May 2021 BAR Decision

BAR 21-05-03

605 Preston Place, Tax Parcel 050111000

Project: Three-story apartment building with below-grade parking

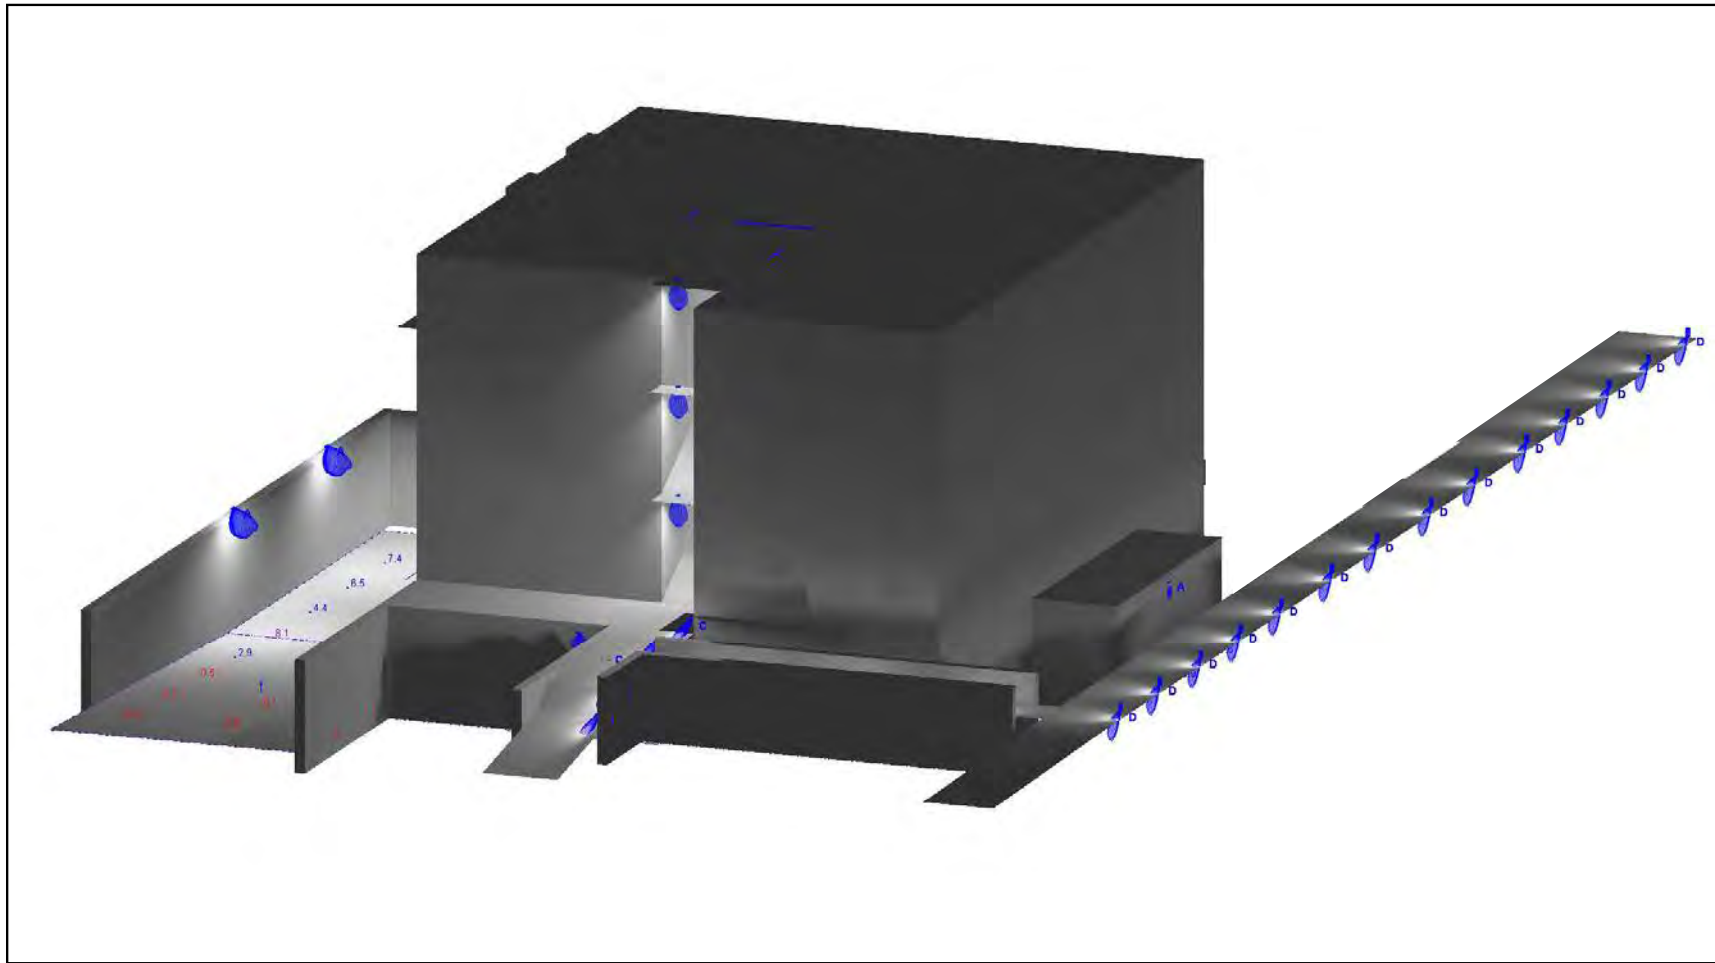
- Plantings: Retain existing trees, especially street trees; protect significant existing trees and other plantings.
 - At the street, two Deodora cypress (30" and 36" caliper) will be retained.
 - A 36" oak will be removed.
 - Fifteen new trees will be planted on the site.

- Lighting: Use light levels that provide for adequate safety, yet do not overly emphasize the site or building.
 - Proposed fixtures available with lamping that is consistent with the BAR's established guidelines: Dimmable; Color Temperature not to exceed 3,000K; Color Rendering Index of not less than 80, preferably not less than 90. BAR should establish a condition that all lamping.
- Parking Areas and Lots: Screen parking lots from streets.
 - Proposed parking is underground, accessible through a side entrance.
 - Surface spaces for three vehicles at the side and rear corner of the new building.

- Requiring that all lamping be dimmable, if that option is available with the specified light fixtures, the Color Temperature not exceed 3,000K, and the Color Rendering Index is not less than 80, preferably not less than 90.
- Underground the new electrical service.
